PRODUCT BULLETIN # 16967

Issue Date: 24-Jan-2013

TITLE: SPI EEPROM Products Timing Exception

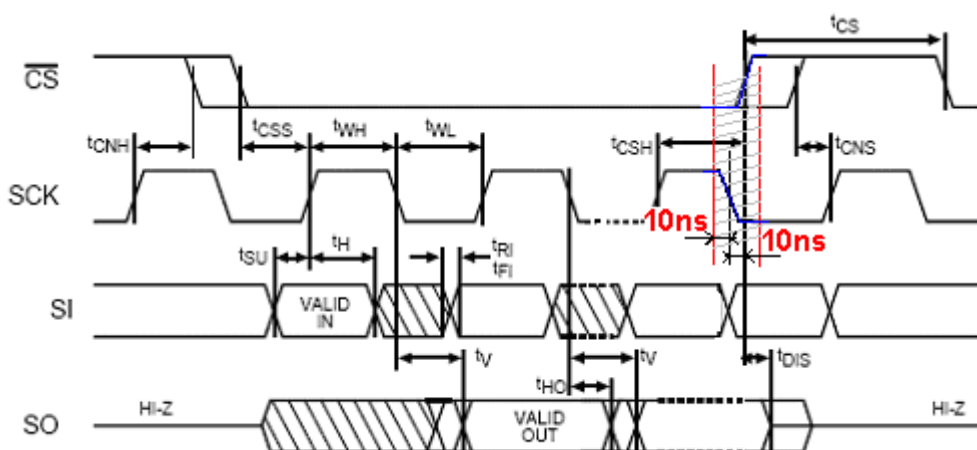
The timing exception refers to the t_{CSH} parameter in the context of the WREN instruction, where t_{CSH} is the delay from the positive Clock (SCK) transition to the positive CS transition (as shown below). The WREN instruction will not be executed (i.e. Write will not be enabled) – if the positive CS transition occurs within fewer than 10 ns either before or after the negative SCK transition:

Since this timing exception does not apply to OKI sourced parts, users switching from OKI to Gresham are urged to validate application compatibility – before deploying Gresham parts into production.

If issues are observed, please contact ON Semiconductor at the above contact point for resolution.
